# STEREO HIGH FIDELITY AMPLIFIER, Type SHFA2

CHANNEL 1

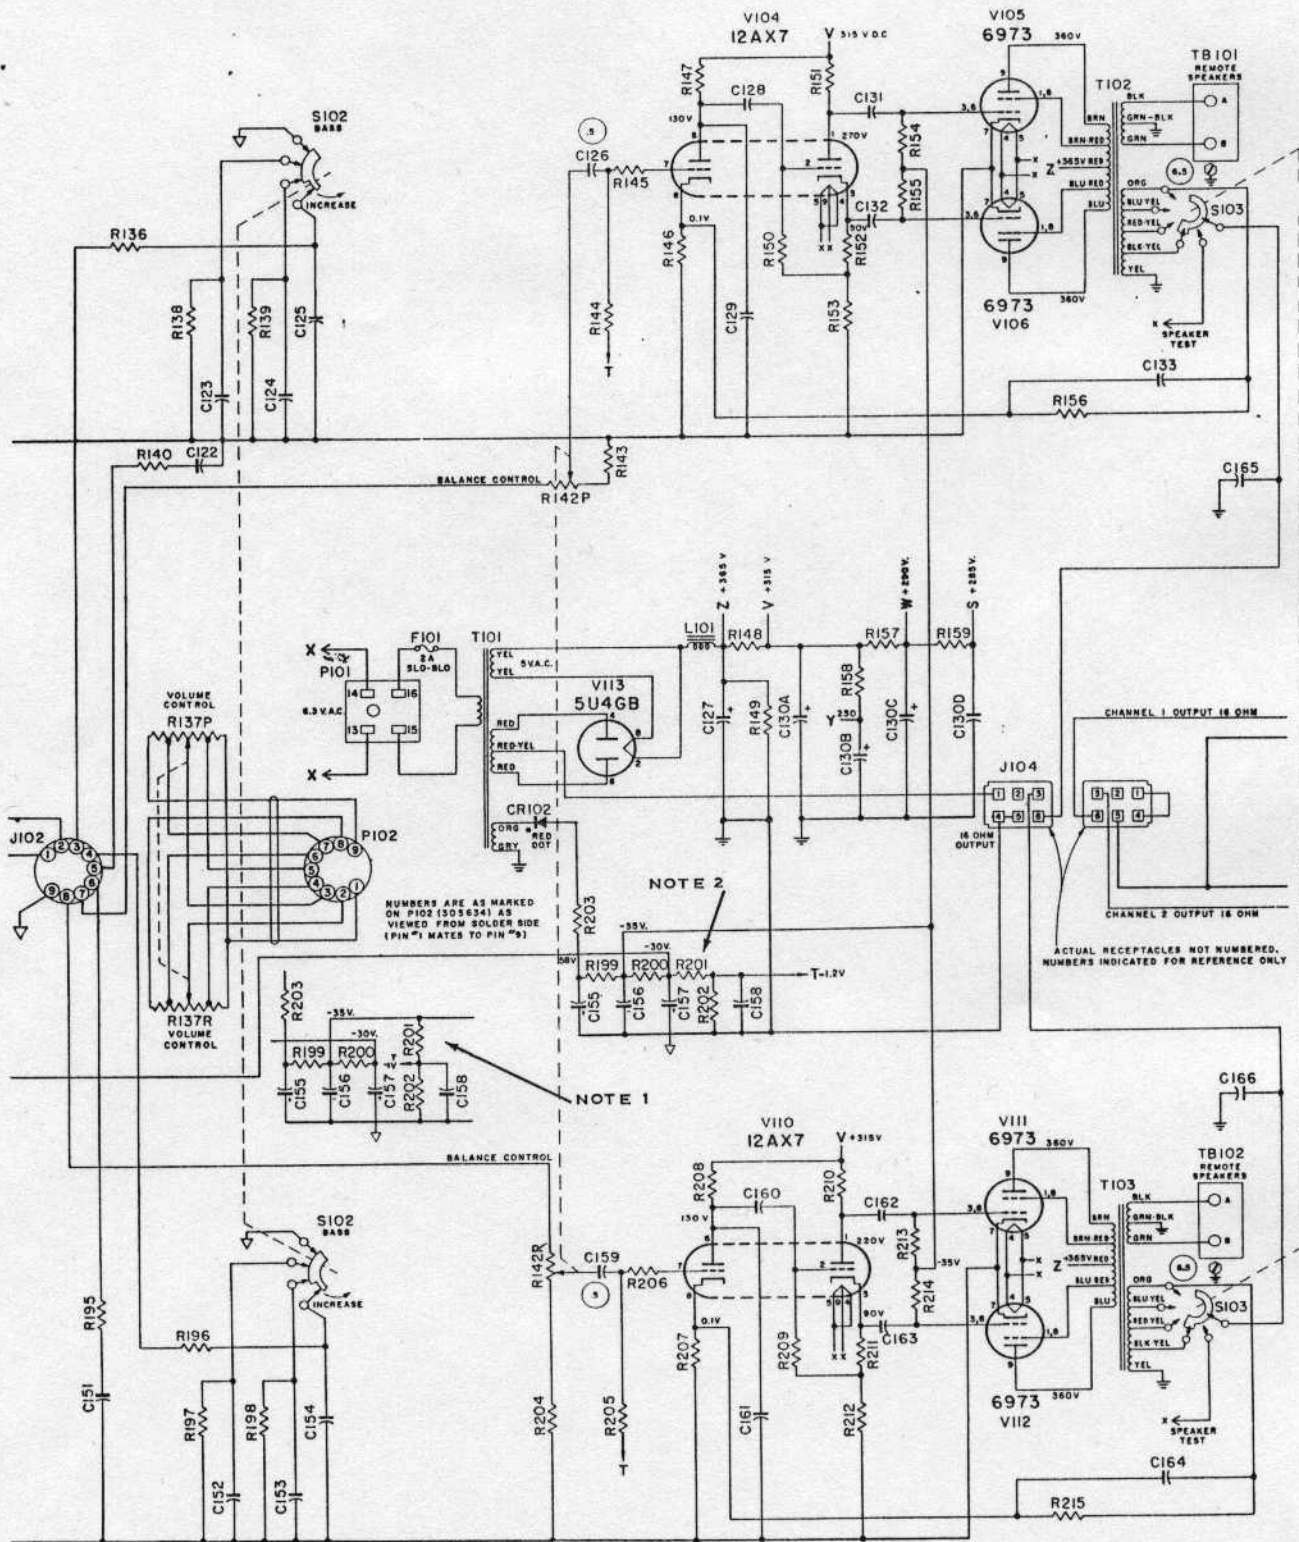
1. SCHEMATIC SECTION SHOWING ORIGINAL LOCATION OF R201.

2. ON LATER AMPLIFIERS IN WHICH R201 IS LOCATED AS SHOWN, RESISTORS R199, R200, R201 AND R202 MUST BE USED COLLECTIVELY AS PART NUMBER AND VALUE INDICATED BY ASTERISK (\*) ON PARTS LIST OF PAGE 4076.
